P802.3bt D3.0 – Fixes to the Autoclass state diagram v100

Figure 145-27—Single-signature PD Autoclass state diagram

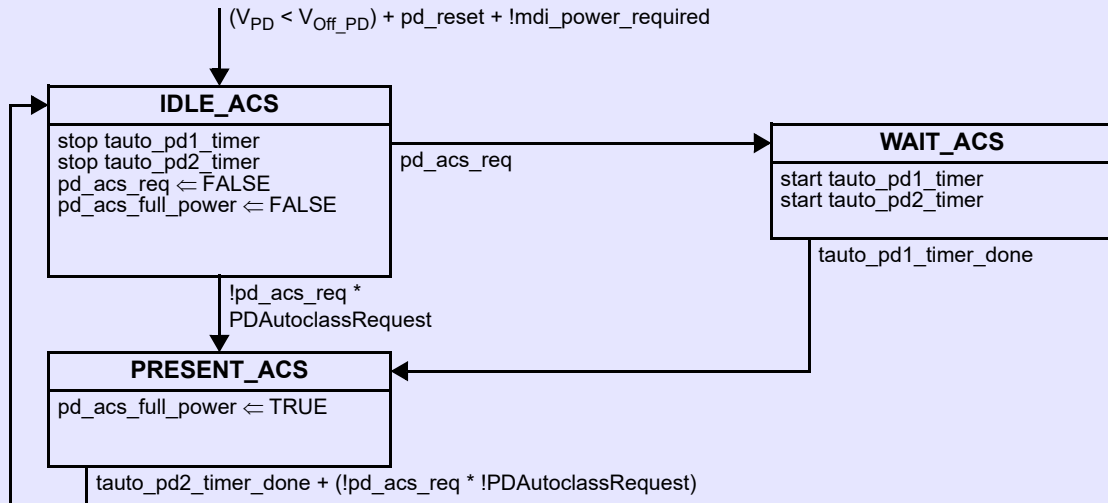
There are mistakes in the Autoclass PD state diagram:

Because `pd_acs_req` is set to `FALSE` in the `IDLE_ACS` state (which is executed continuously until $V_{PD} > V_{Off_PD}$), the PD instantly forgets it has to do Autoclass based on Physical Layer. By clearing `pd_acs_req` in `WAIT_ACS`, we no longer can have a single `PRESENT_ACS` state because we can't distinguish the exit conditions.

Replace Figure 145-27 as follows:
